NDOR PALISADE MAINTENANCE FACILITY

Attachment No. M100-2
to Addendum No. 1
Dated: Feb. 17, 2014

Attachment No. E200-1
 to Addendum No. 1
 Dated: Feb. 17, 2014

Attachment No. E500-1
 to Addendum No. 1
 Dated: Feb. 17, 2014

UTILITY PLAN

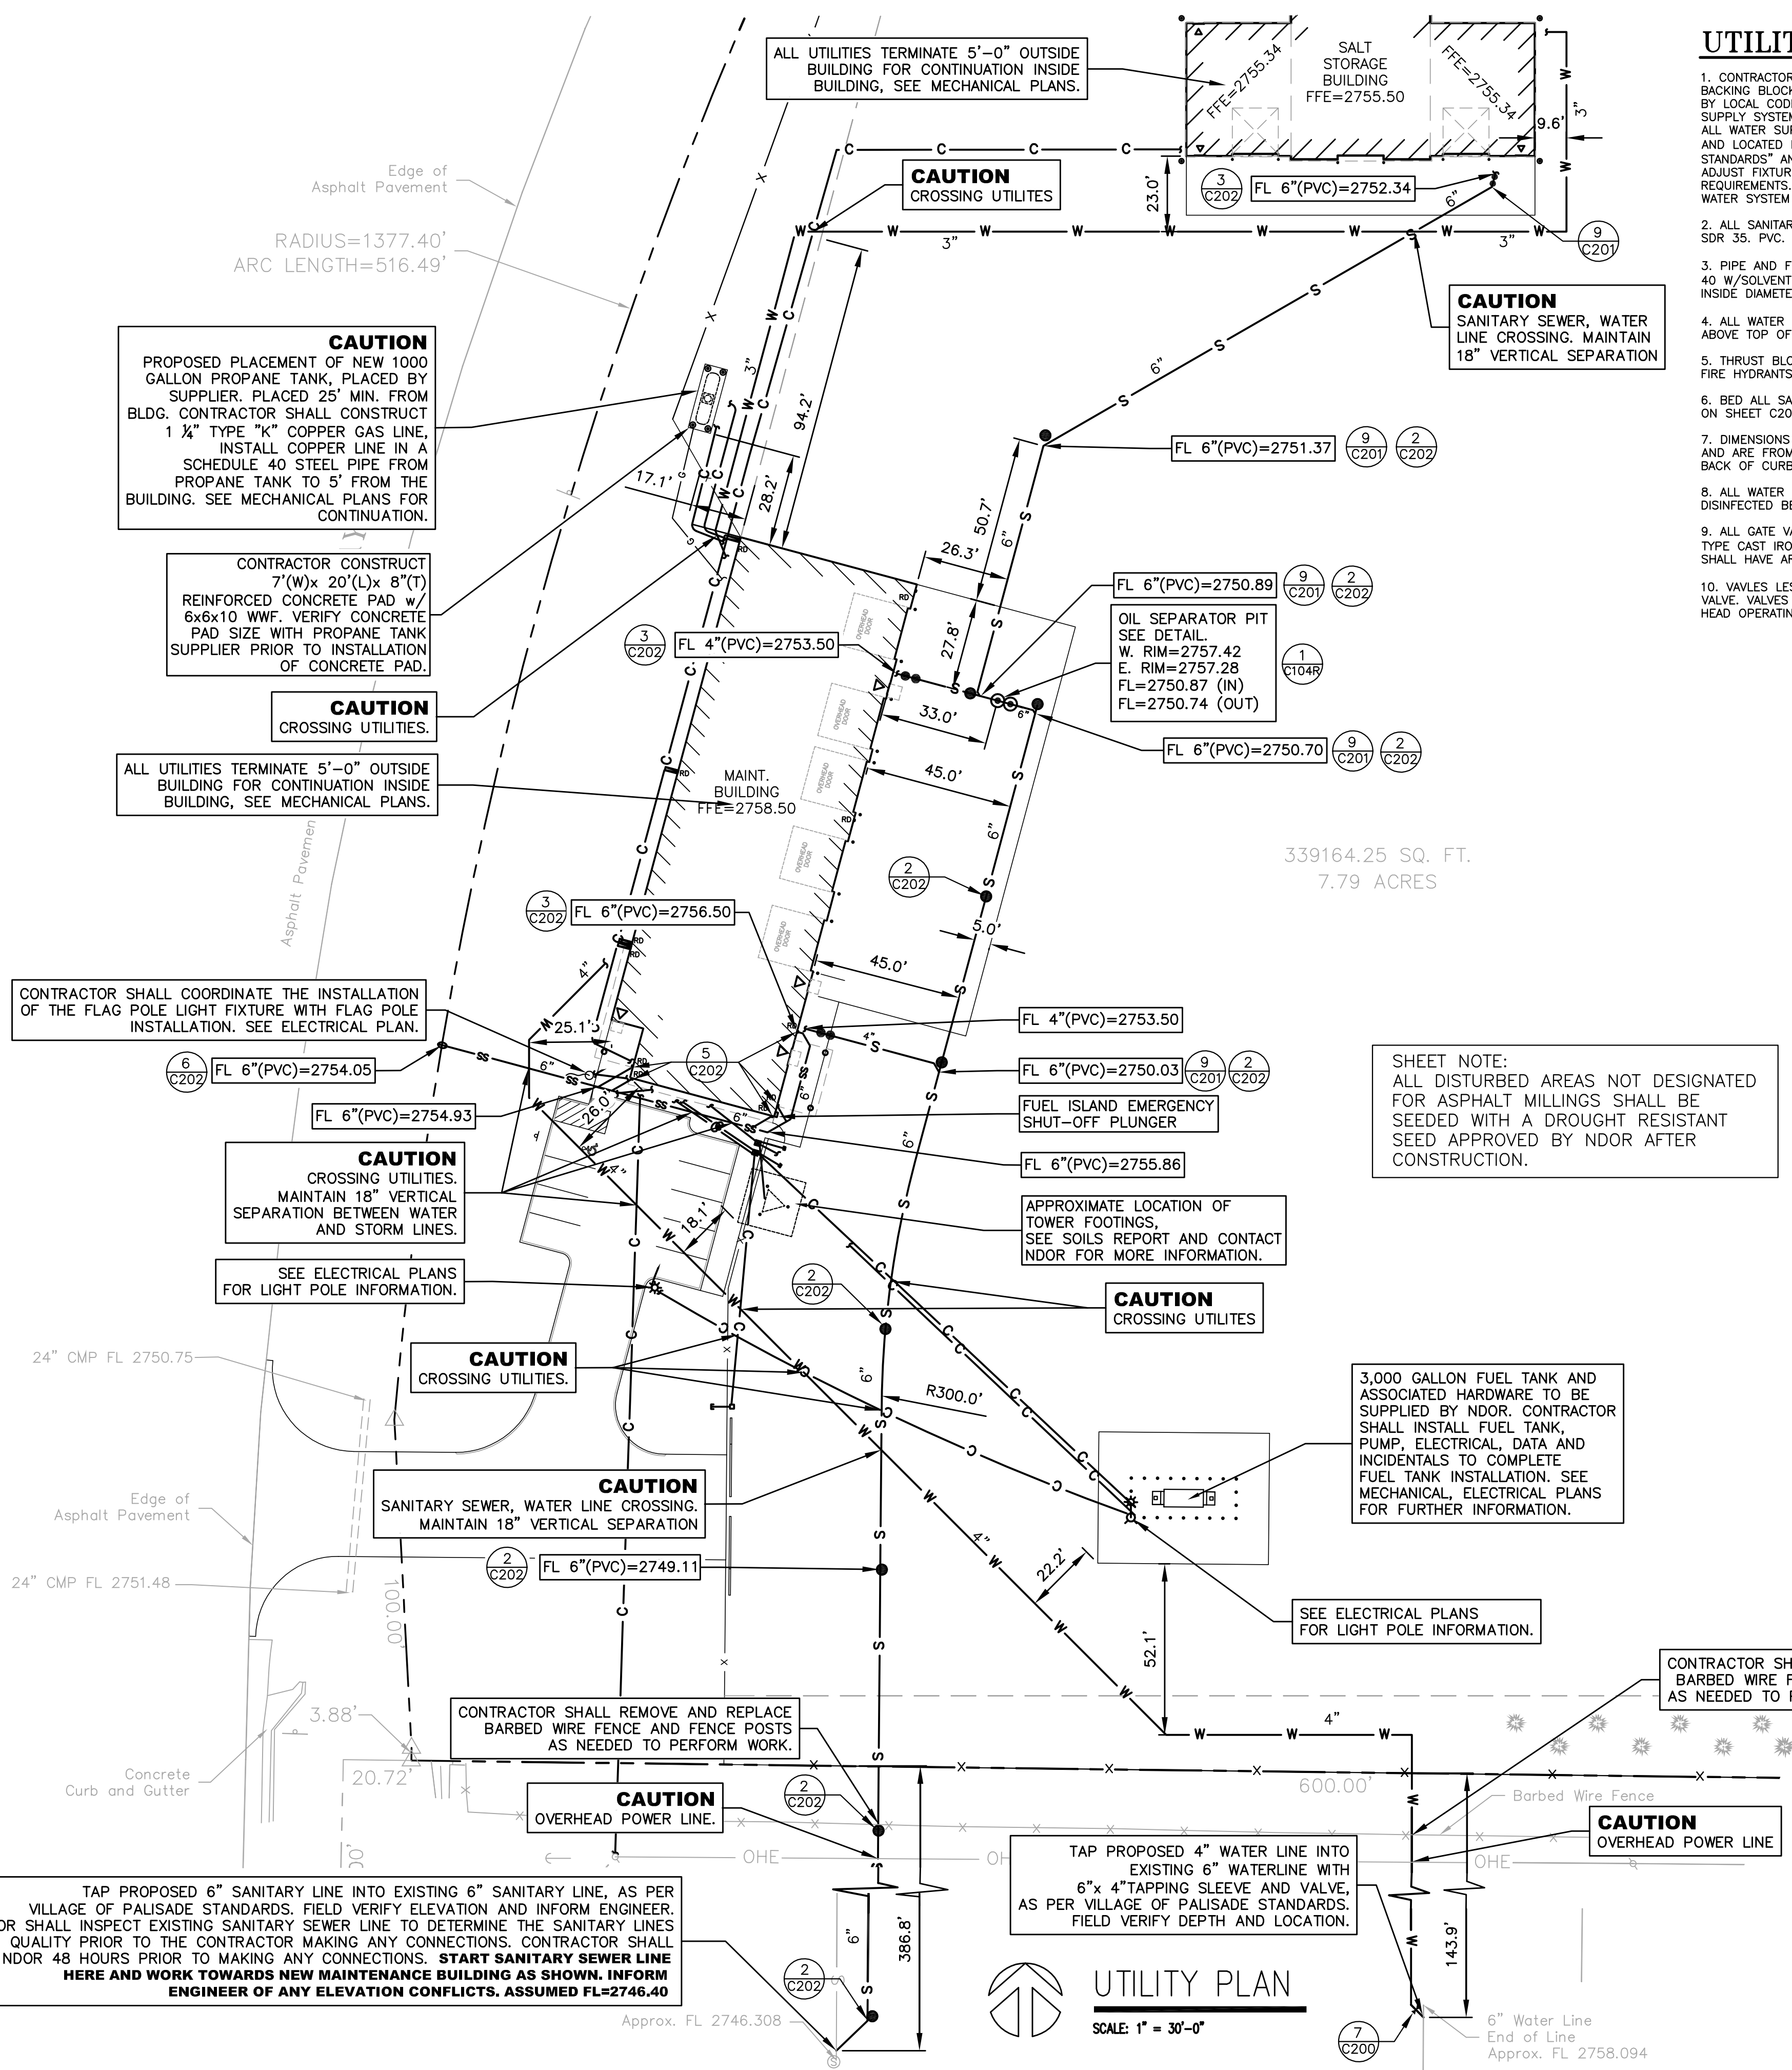
ISSUED FOR:	DATE:	BY:	REVIEW BY:
65% REVIEW SET	12/18/13	SDB/NB	NB/DR
95% REVIEW SET	01/15/14	SDB/NB	NB/DR
100% CONSTRUCTION SET	02/03/14	SDB/NB	NB/DR
REV. SANITARY, WATER, SSB FLR ELEV.	02/11/14	SDB/NB	NB/DR

GRADING PLAN

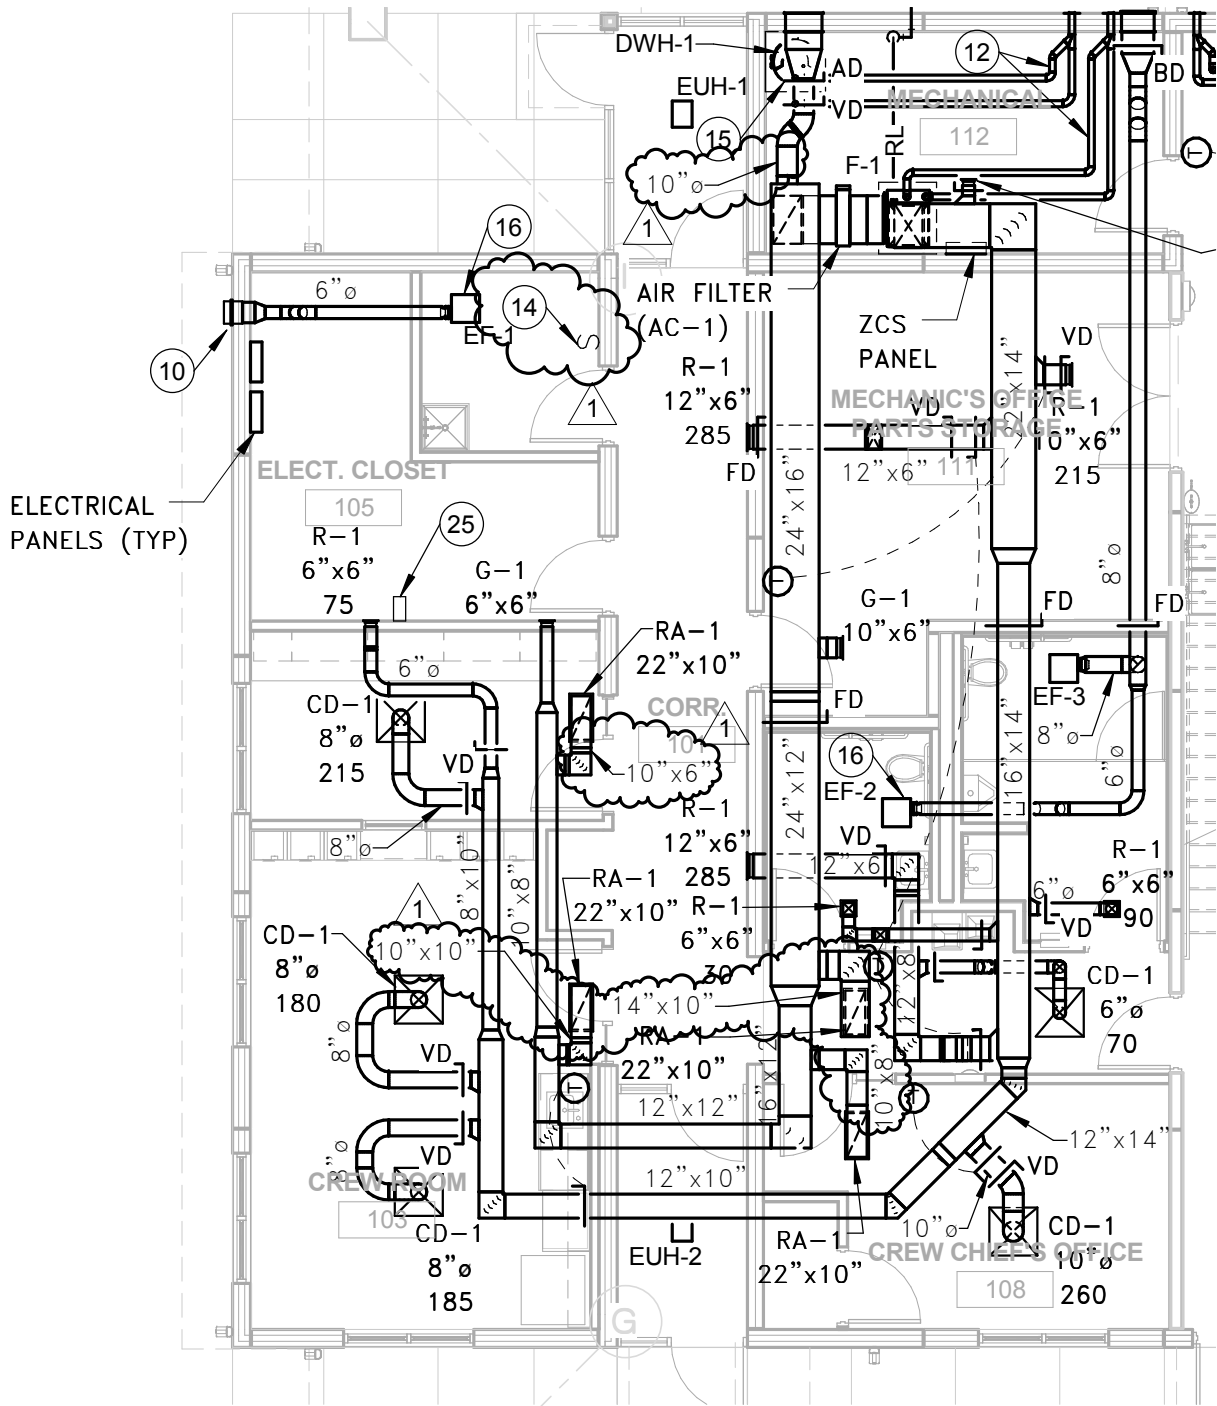
ISSUED FOR:	DATE:	BY:
REVISED FINISH FLOOR ELEVATION OF SALT STORAGE BUILDING	02/11/14	SDB

MAIN LEVEL HVAC PLAN

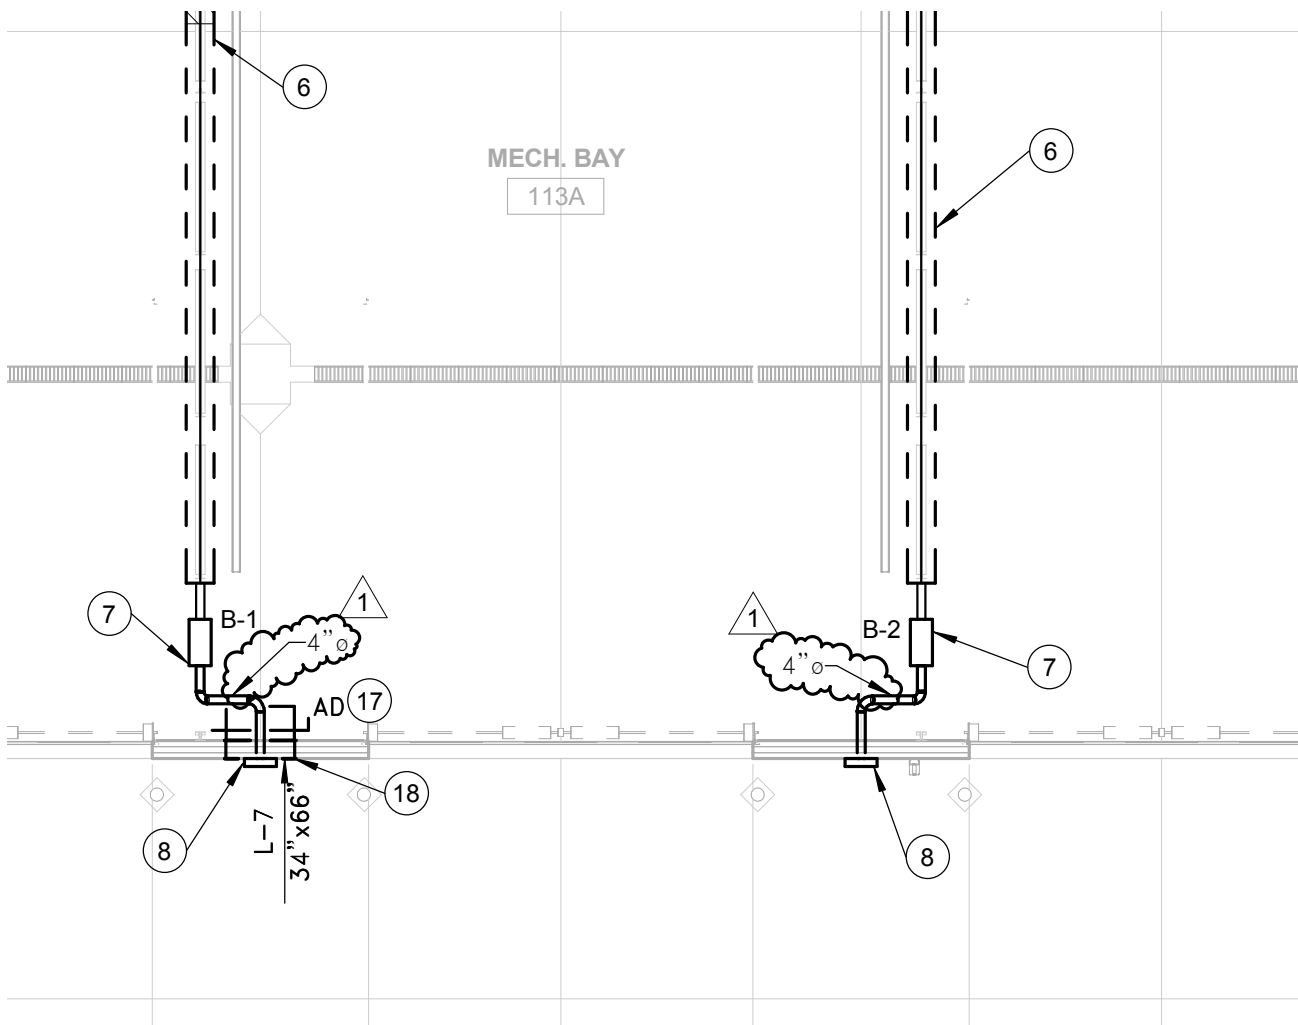
20. MAKE-UP AIR UNIT TYPE 1 (MAU-1) AND EXHAUST FANS TYPE 7,8 (EF-7,8) SHALL BE CONTROLLED BY A 24V 3-THROW SWITCH (LOW/HI/OFF). SWITCH AT LOW SETTING SHALL OPEN AUTOMATIC DAMPER (AD) ON LOUVER TYPE 9 (L-9) AND OPERATE MAU-1 AT 50%, ENDSWITCH ON L-9 SHALL ENERGIZE MOTOR STARTER FOR EF-7. SWITCH AT HI SETTING SHALL OPEN AD ON L-9,10 AND OPERATE MAU AT 100%, ENDSWITCH ON L-10 SHALL ENERGIZE MOTOR STARTER FOR EF-8. PROVIDE NECESSARY RELAYS/TRANSFORMERS AS REQUIRED FOR A COMPLETE AND FUNCTIONING SYSTEM, SEE EQUIPMENT CONTROLS SCHEDULE ON THIS SHEET.
